Errata for the
PCI Express® Base Specification
Revision 2.1

April 17, 2010

Errata for the PCI Express Base Specification, Revision 2.1

OM13771A

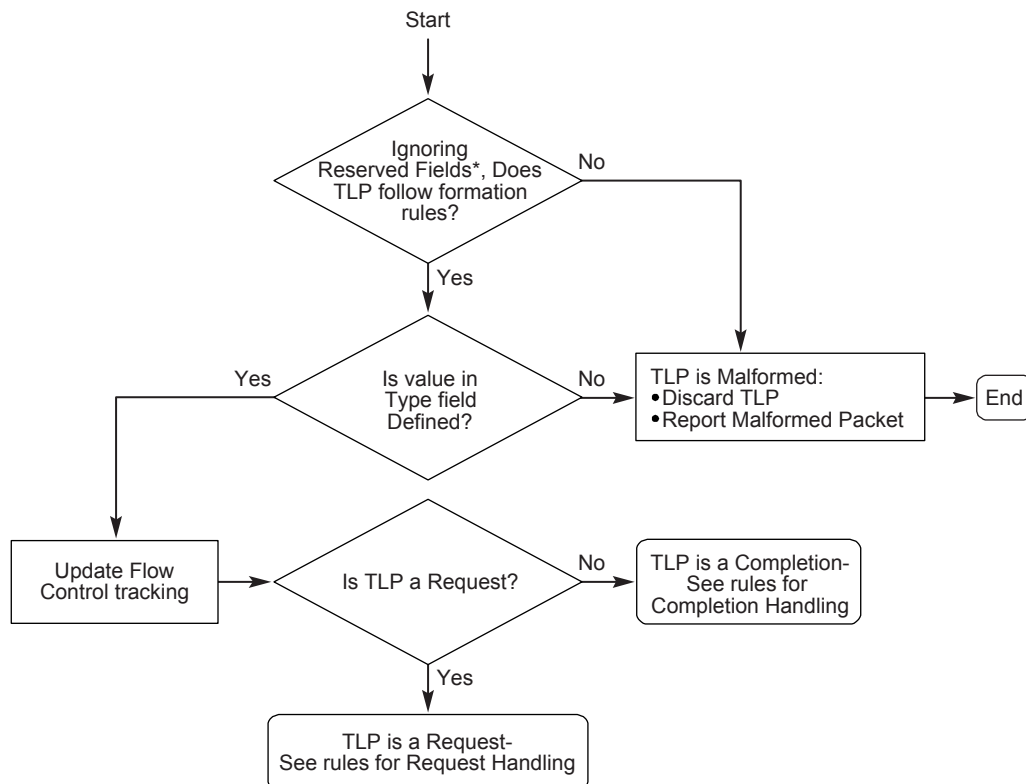
In Section 2.3, page 102, replace Figure 2-30: Flowchart for Handling of Received TLPs with the following:

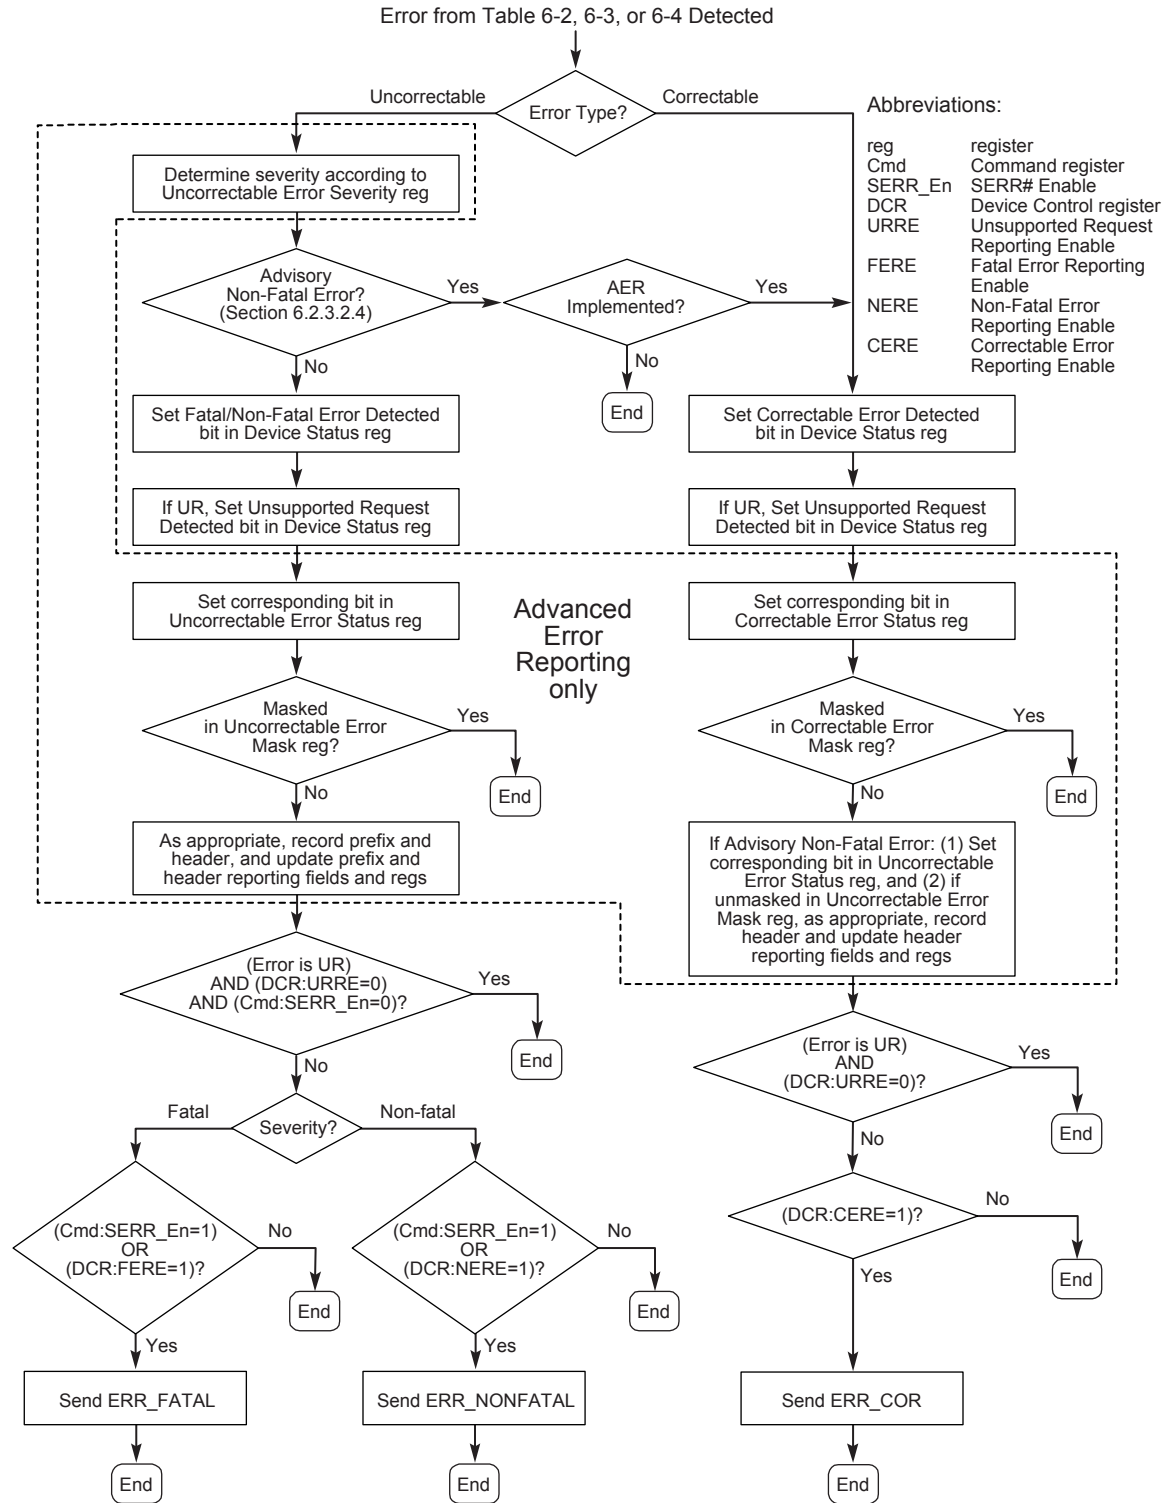
In Section 2.7.1, page 142, lines 21 and 26, make the following edits:

A 32-bit ECRC is calculated for the ~~entire~~ TLP (~~End-End TLP Prefixes~~, header, and data payload) using the following algorithm and appended to the end of the TLP (see Figure 2-3):

- ☐ The ECRC value is calculated using the following algorithm (see Figure 2-37).
- ☐ The polynomial used has coefficients expressed as 04C1 1DB7h
- ☐ The seed value (initial value for ECRC storage registers) is FFFF FFFFh
- ☐ All invariant fields of the TLP's ~~End-End TLP Prefixes (if present)~~, header, and the entire data payload (if present) are included in the ECRC calculation, all bits in variant fields must be set to 1b for ECRC calculations.

OM14544C

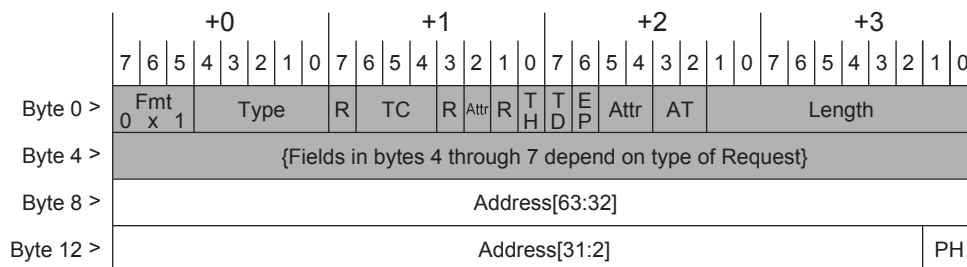
In Section 2.2.4.1, page 64, replace Figure 2-7: 64-bit Address Routing with the following:

OM14543C

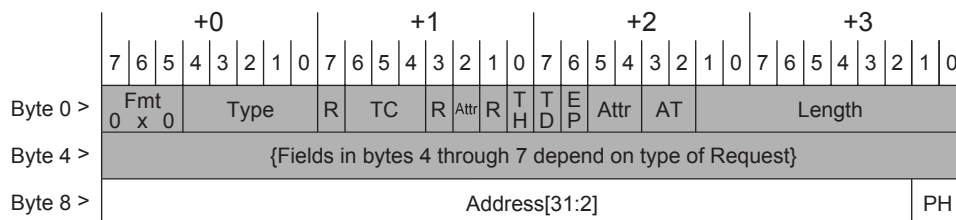
In Section 2.2.4.1, page 64, replace Figure 2-8: 32-bit Address Routing with the following:

OM13764C

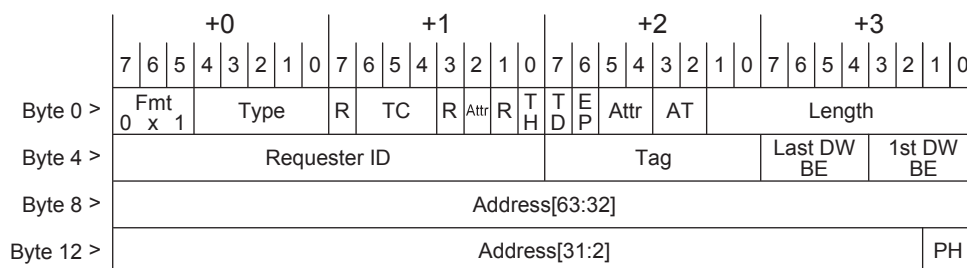
In Section 2.2.7, page 77, replace Figure 2-15: Request Header Format for 64-bit Addressing of Memory with the following:

OM13763C

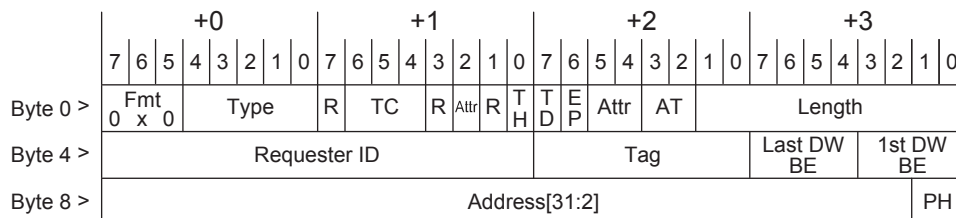
In Section 2.2.7, page 77, replace Figure 2-16: Request Header Format for 32-bit Addressing of Memory with the following:
